COLORADO
Division of Reclamation,
Mining and Safety
Department of Natural Resources

February 22, 2021

RE: Adequacy Review No. 2; 112c Construction Materials Amendment Application (AM-05), Pueblo East, Permit No. M-1986-015

Attachments: AM-01, 2002, Site Map
AM-02, 2004, Site Map
AM-03, 2007, Site Map
AM-04, 2011, Site Map

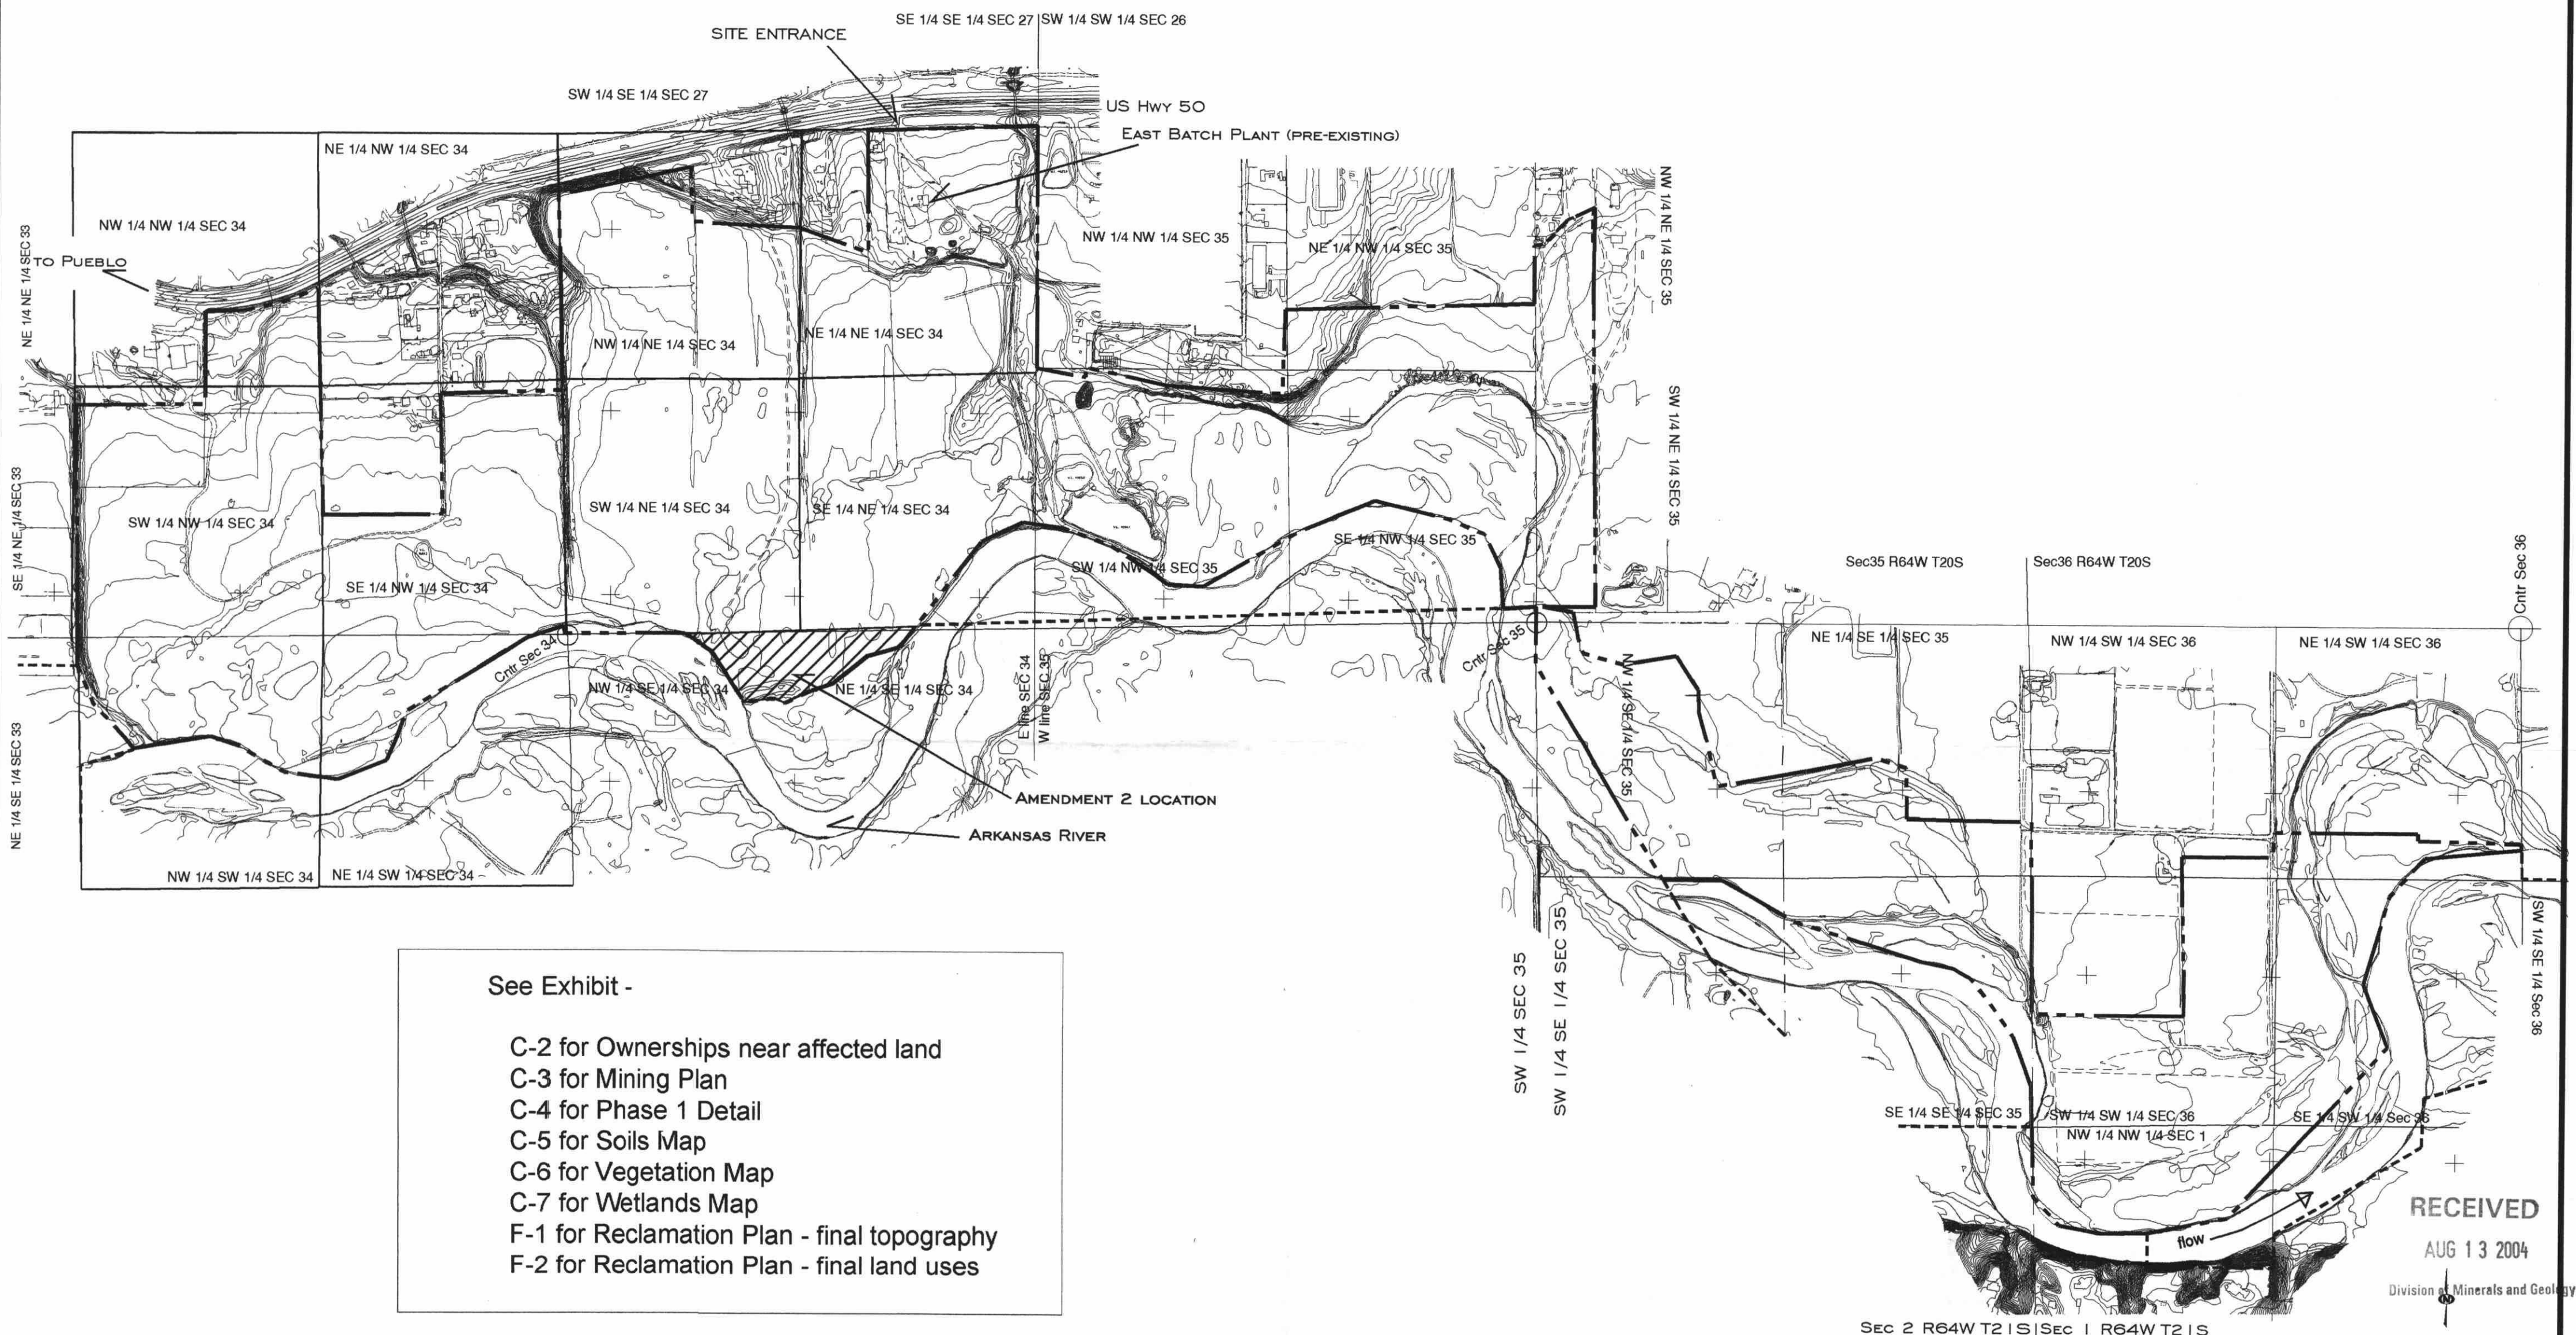
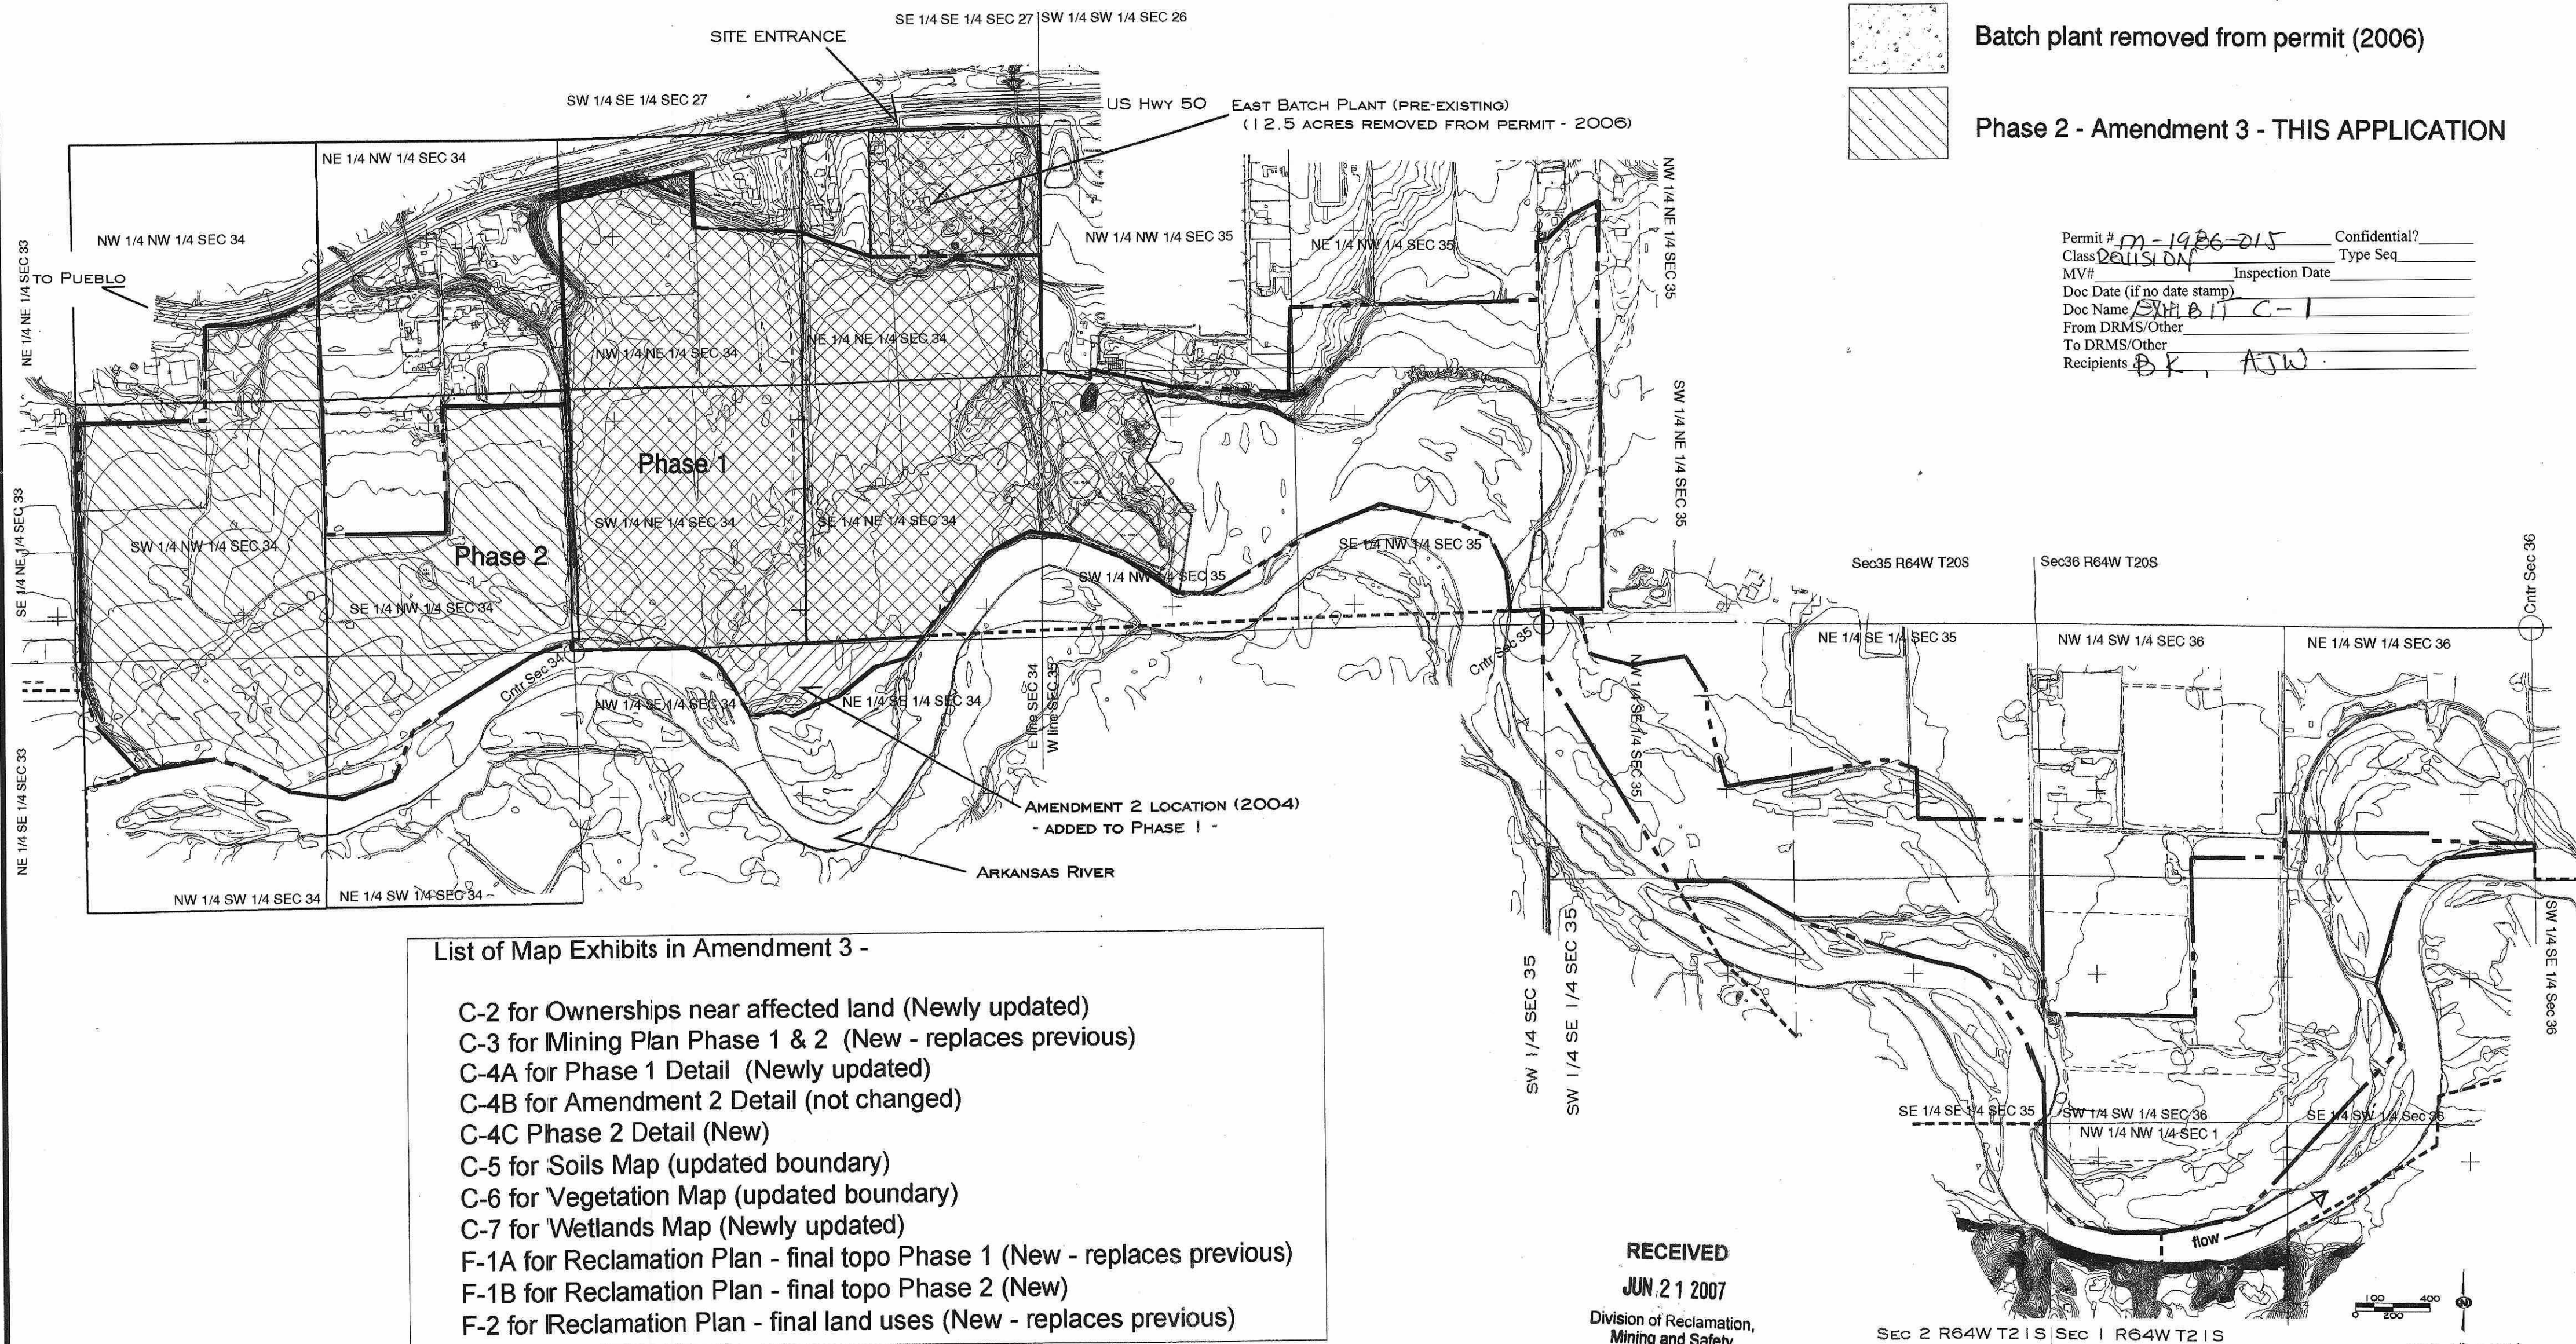
2. Please provide an updated Index Map that depicts the current approved permit boundary along with acreage. The map provided does not reflect acreage that was added to the permit in AM-01 to the southeast and the 28 acres that was added with the approval of AM-04 south of the Arkansas River. Attached to this review are the permit boundary maps from the four Amendments to help the operator.
